No: 15 TL-5  
March 13, 2015

TO: Service Locations  
FROM: Service Systems Development  
Subject: **DAVCO Shop Pro® FXP 95**

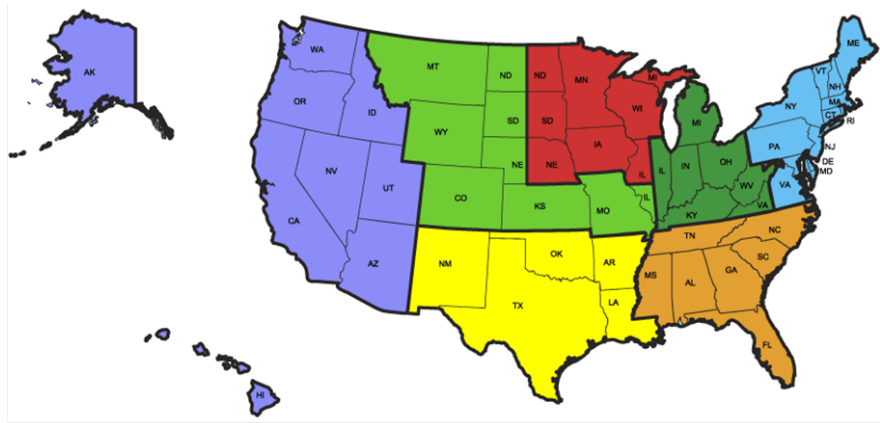
DAVCO has created an updated version of the Shop Pro FXP. This update allows the Shop Pro to meet EPA07 – GHG14 priming pressure requirements for all repair and maintenance procedures of the DD engines. Additionally, the new Shop Pro meets the increased priming pressure requirements for all GHG17 DD engines. The unit will be called the Shop Pro FXP95 and painted black to differentiate from the earlier, lower pressure version. For those who already own a Shop Pro, an upgrade kit is available which will increase the pressure to the same as the new design. The following options will be available:

- Fixed Pressure Unit – Provides 95 psi at all times
- Regulated Pressure Unit - Adjustable from 50 – 95 psi for non-Detroit engines
- Fixed Pressure Upgrade Kit – Allows an existing unit to be upgraded to the 95 psi fixed pressure system
- Regulated Pressure Upgrade Kit - Allows an existing unit to be upgraded to an adjustable unit (from 50 – 95 psi)
